Permit To Take Water No. 1381-95ATPY for Triton Water
Canada Holdings, Inc. for bottling water purposes

RE: Report ADM-2021-042 Triton Water Permit to Take Water Renewal

SUBJECT: Triton Water Canada Holdings, Inc. (formerly Nestle Canada) Permit to Take Water Application

figure 5.5
 DRAWDOWN IN AMABEL (2500 Lpm)
 2010 ANNUAL MONITORING REPORT
 NESTLÉ WATERS CANADA
 Guelph, Ontario

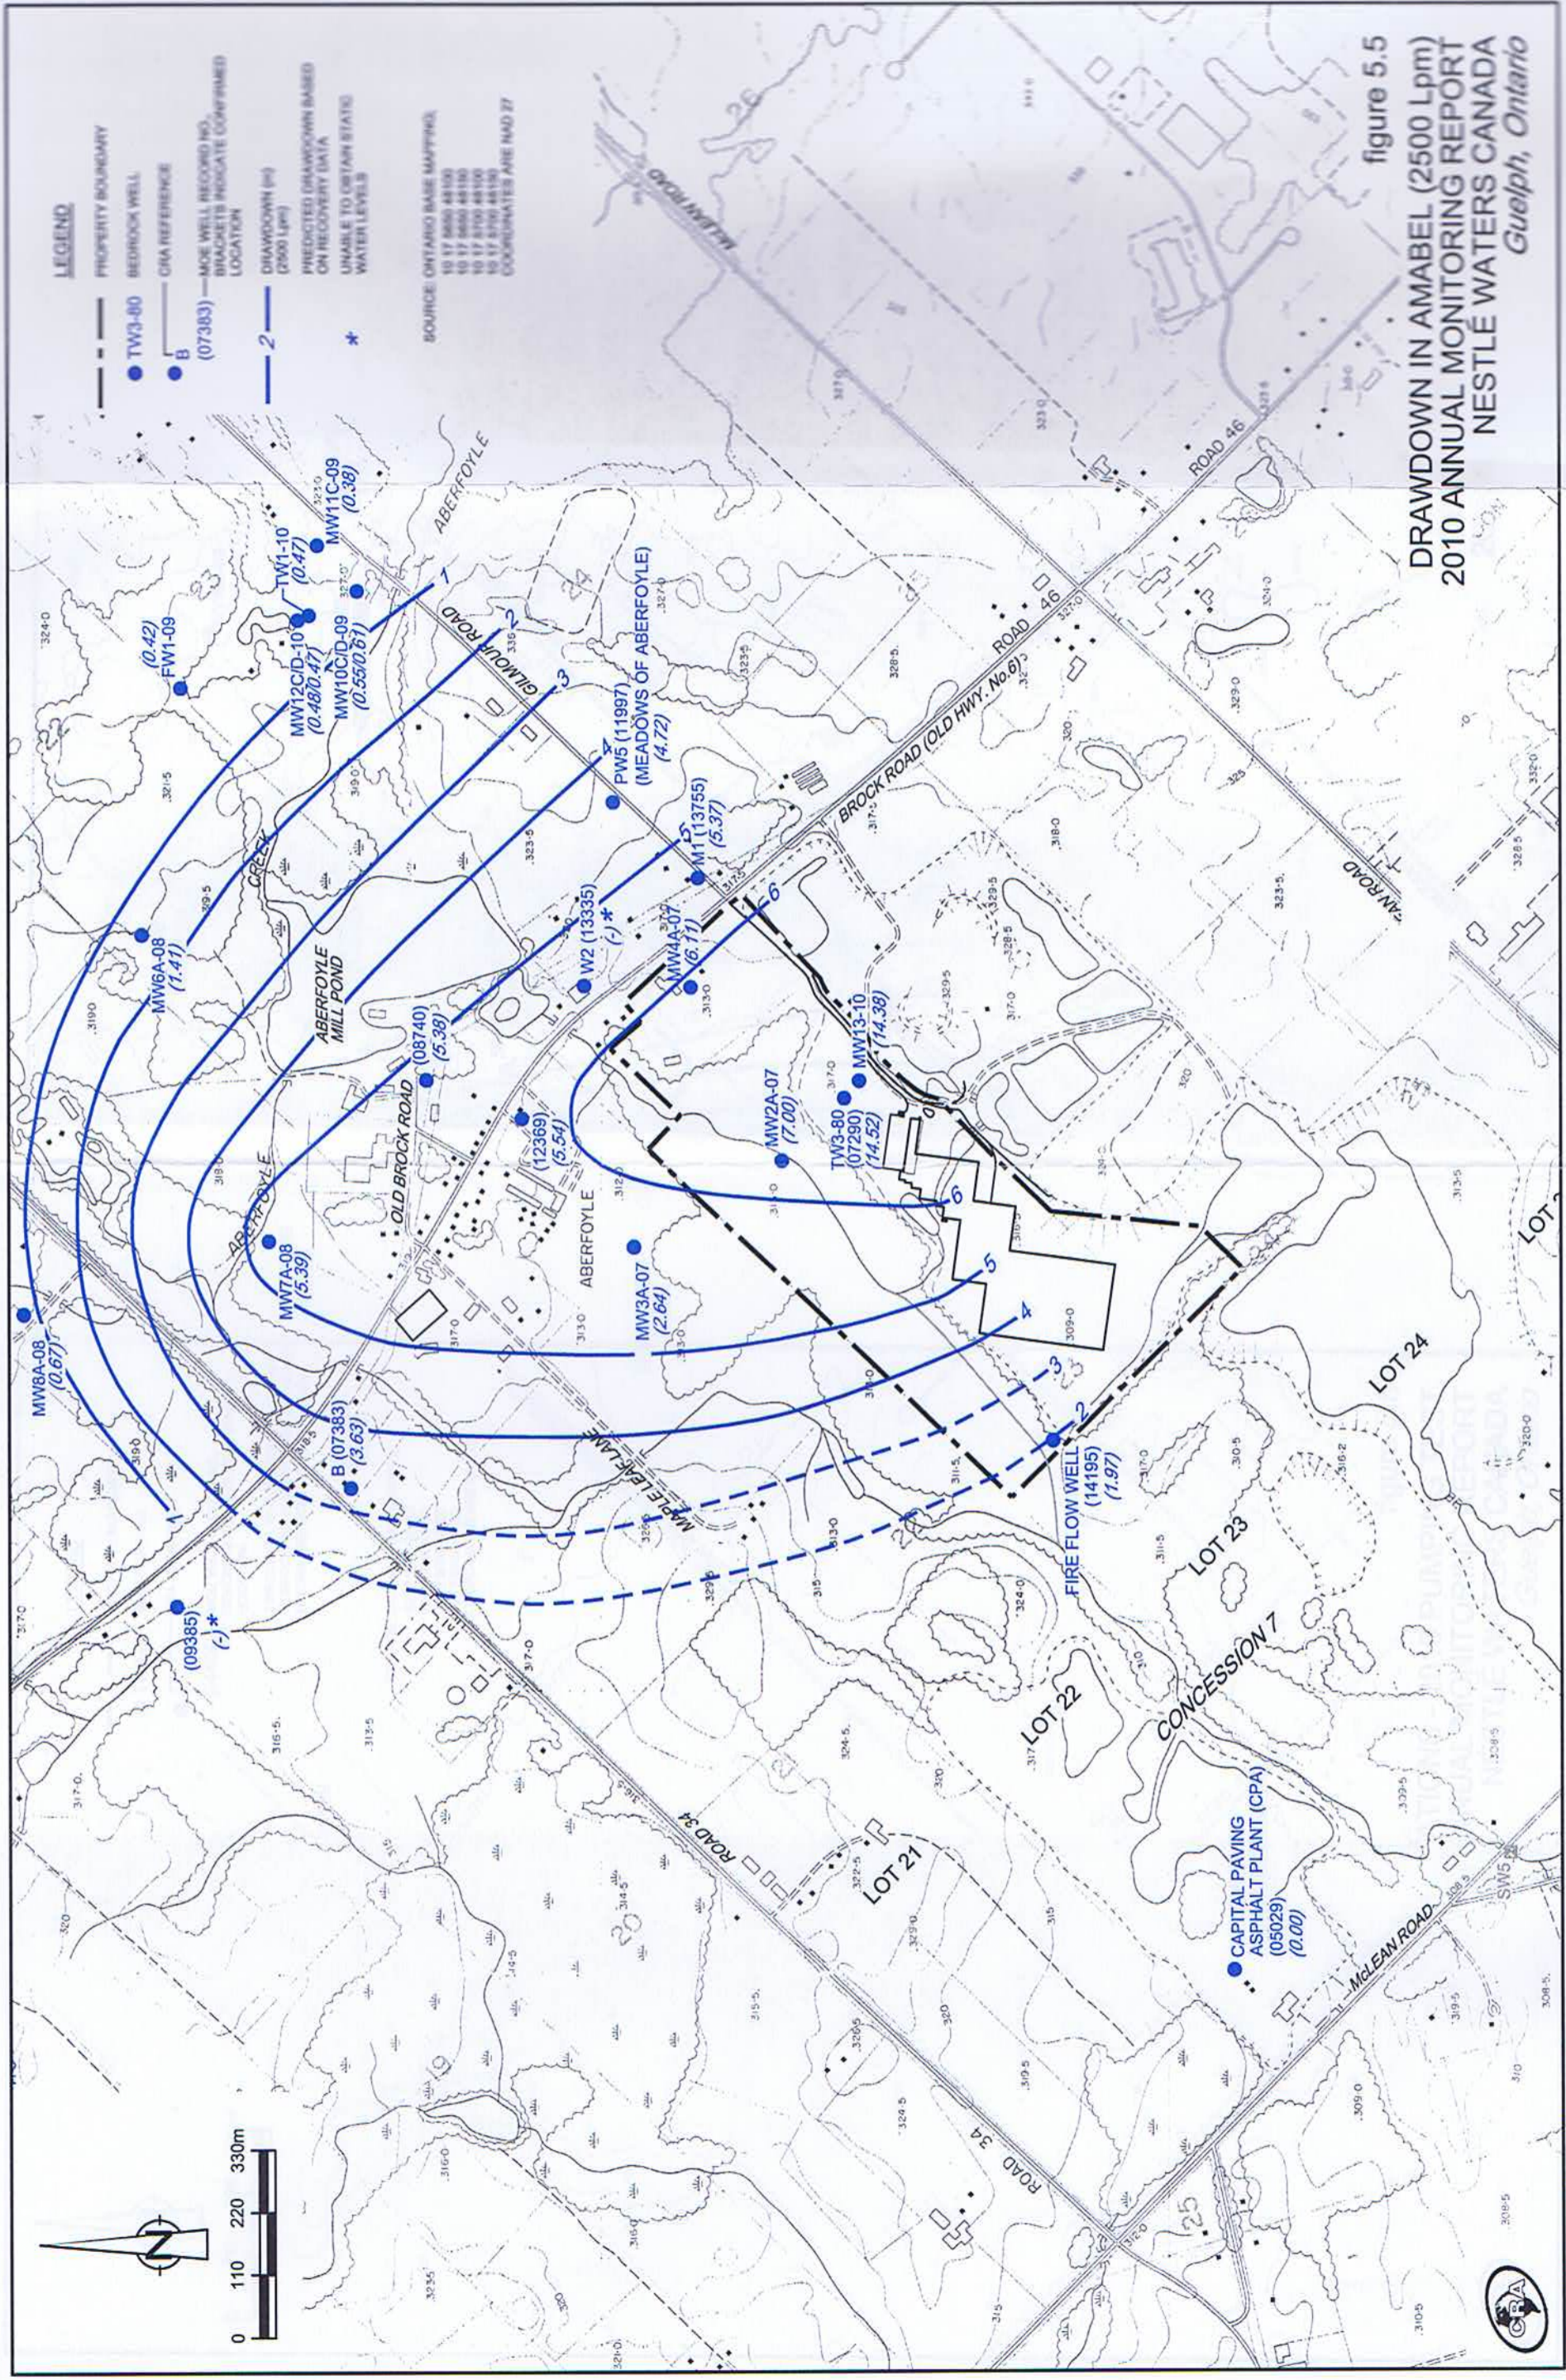
The area of influence of well TW3-80 is not insignificant in either the Goat Island/Gasport aquifers or the Guelph aquifer. The attached Figures 5.5 and 5.8 of the 2010 Annual Report (CRA, 2011) clearly show the extent that the water taking has on water levels in these aquifers. A lowering of the water level in these aquifers may not be problematic for private/communal wells in the area given the ability of both the Guelph and Goat Island/Gasport aquifers to produce water. However, given the measured drawdown of approximately five metres in the Goat Island/Gasport aquifers and three metres in the Guelph aquifer, the lower water levels warrant reviewing the available drawdown in private wells in Aberfoyle during pumping conditions (of private wells) to ensure that there is sufficient availability. The effect of lower water levels on the natural environment will be discussed elsewhere in this letter.

figure 5.8
 DRAWDOWN IN GUELPH (2500 Lpm)
 2010 ANNUAL MONITORING REPORT
 NESTLÉ WATERS CANADA
 Guelph, Ontario

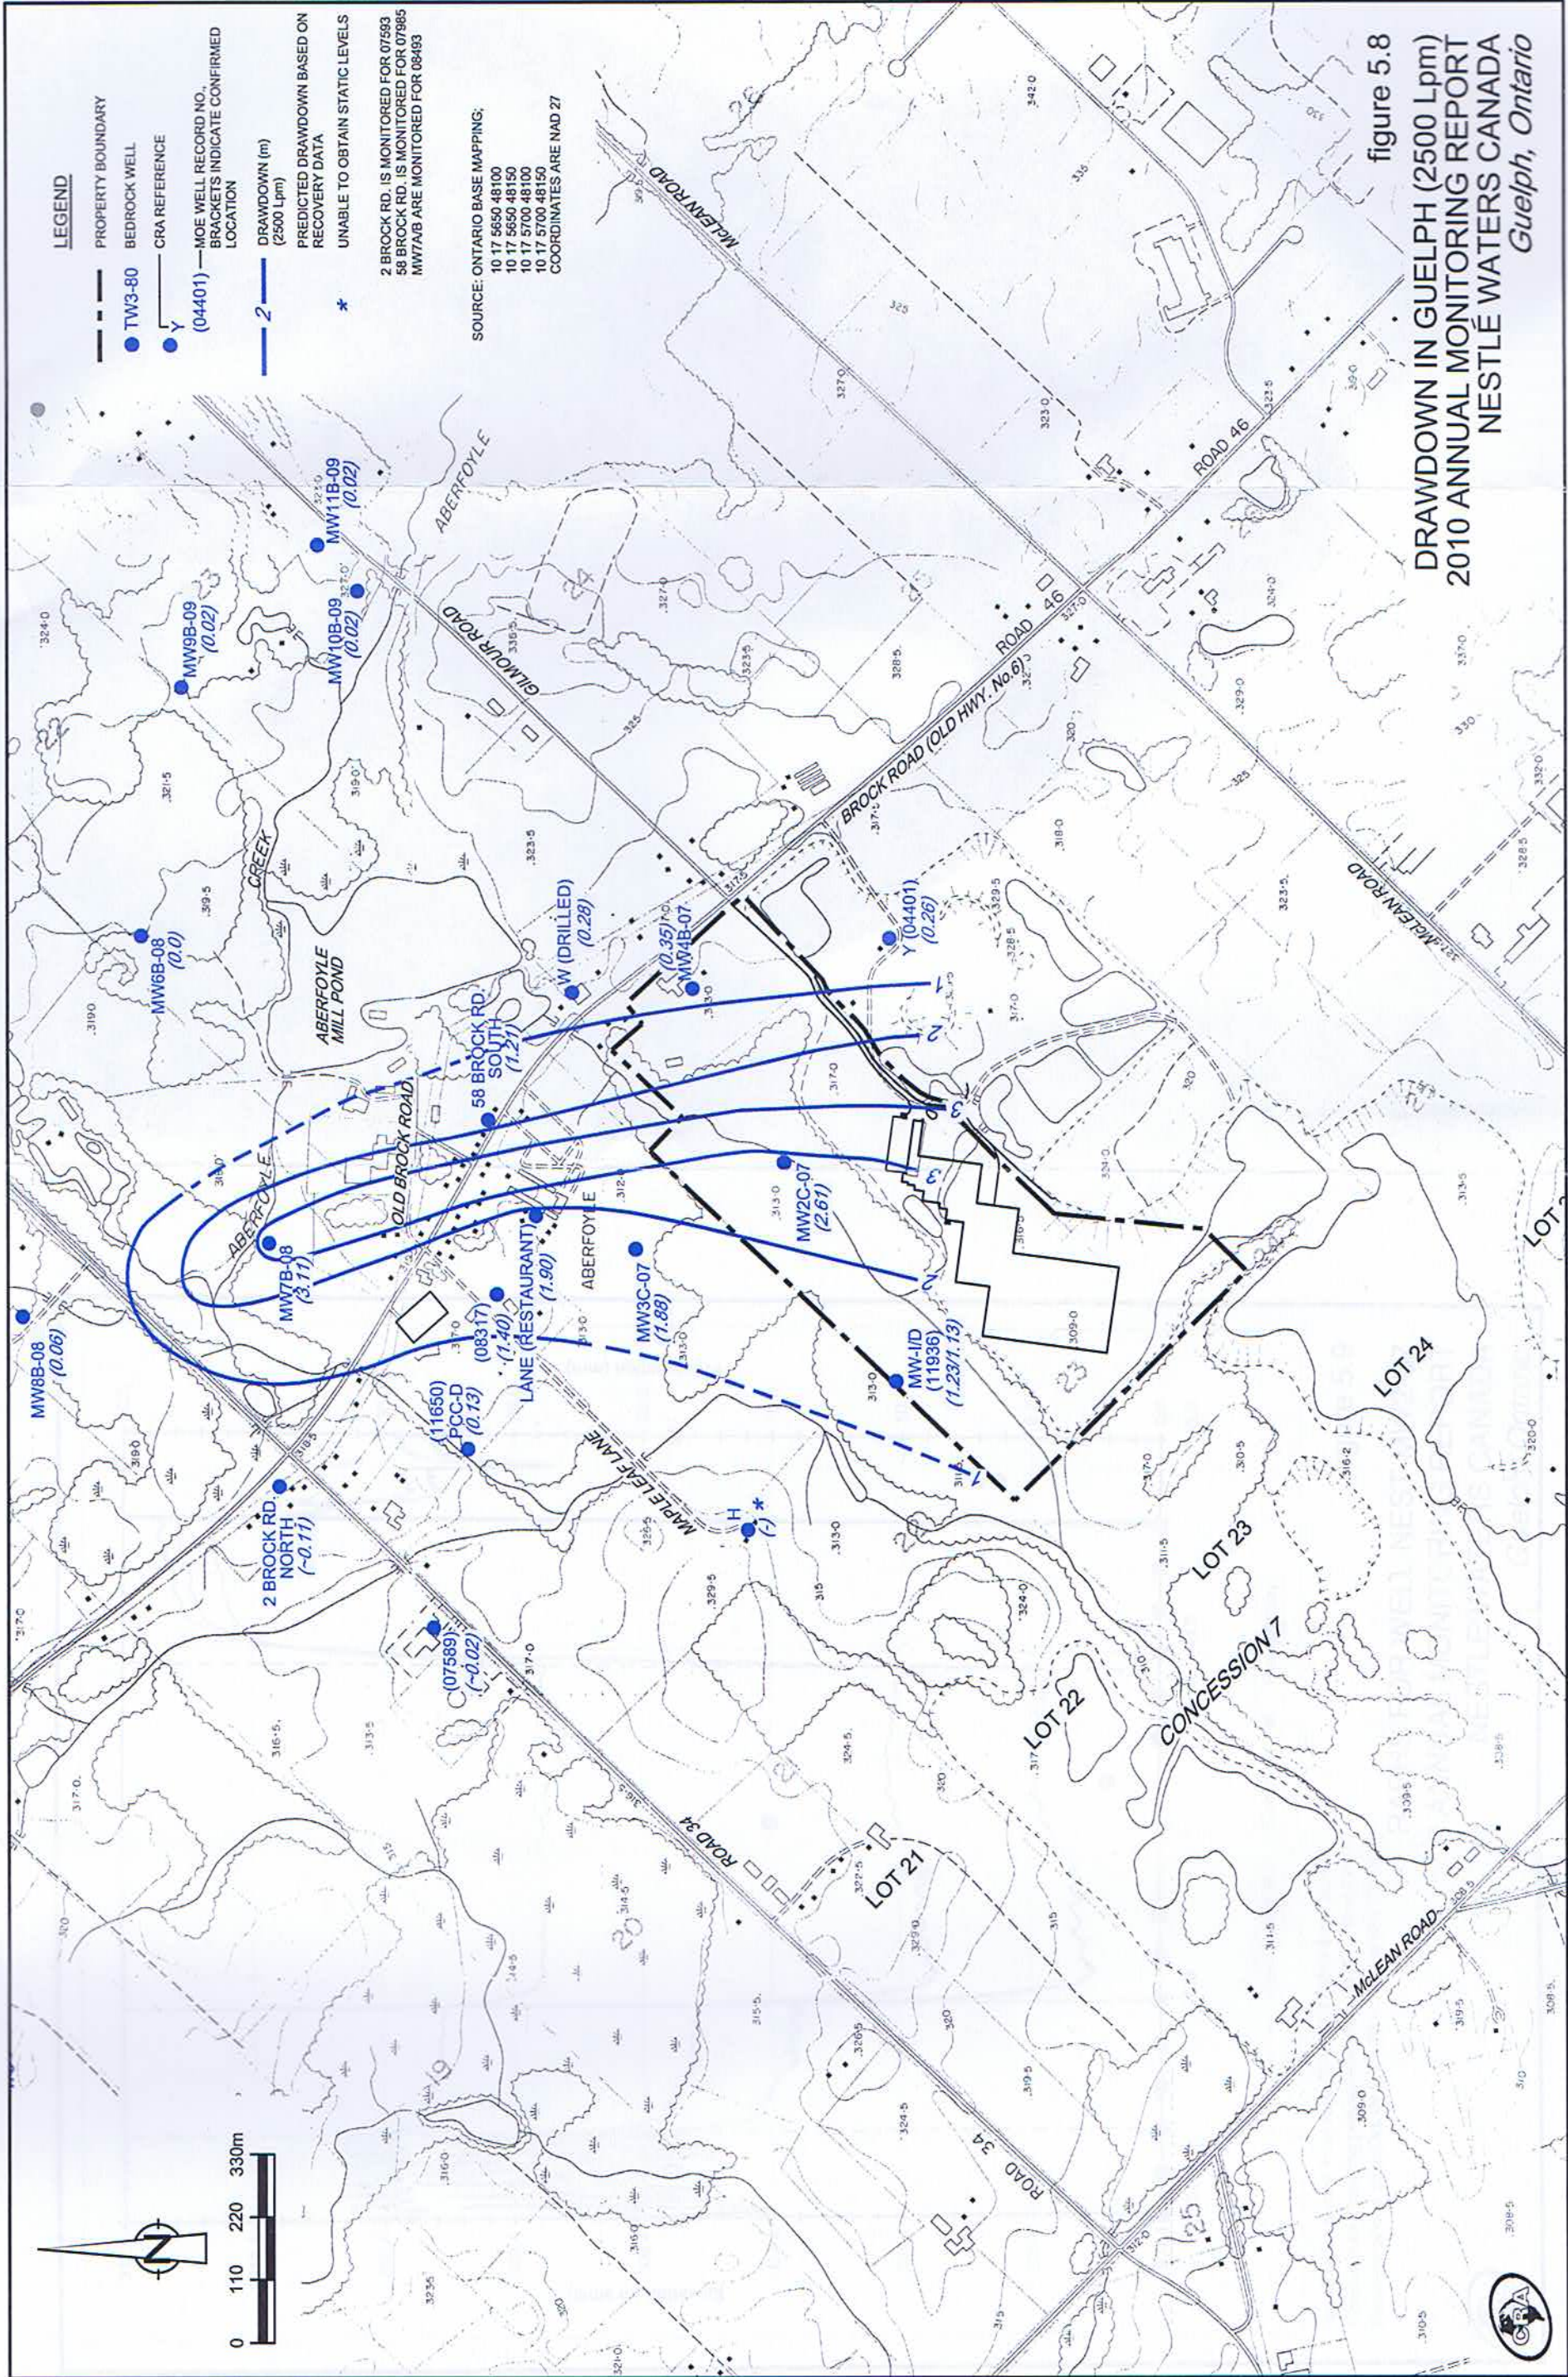
The observation that drawdown in the Goat Island aquifer results in drawdown in the Guelph aquifer suggests that there is a reasonable hydraulic connection between these two aquifers. The Eramosa Formation separates the two aquifers, and although it is apparent that the Eramosa somewhat retards the effect of drawdown (from five metres drawdown to three metres drawdown) there is still a significant drawdown effect over a large area beneath the urban center of Aberfoyle in the Guelph aquifer. Given the relatively rapid response and the magnitude of the response in the Guelph aquifer due to pumping from the Goat Island aquifer, the effectiveness of the Eramosa Formation as an aquitard is questionable. This may be due to natural factors such as a thinning of the aquitard, or vertical fracturing. However, the observed drawdown in the Guelph Formation is also brought about by short circuiting in “Eramosa Penetrating” wells. These Eramosa Penetrating Wells are “open” to both the Guelph aquifer and the Goat Island aquifer. When pumping from the Goat Island aquifer occurs, water is drawn from the Guelph aquifer via the well bore. There are two main concerns in regards to the short circuiting;
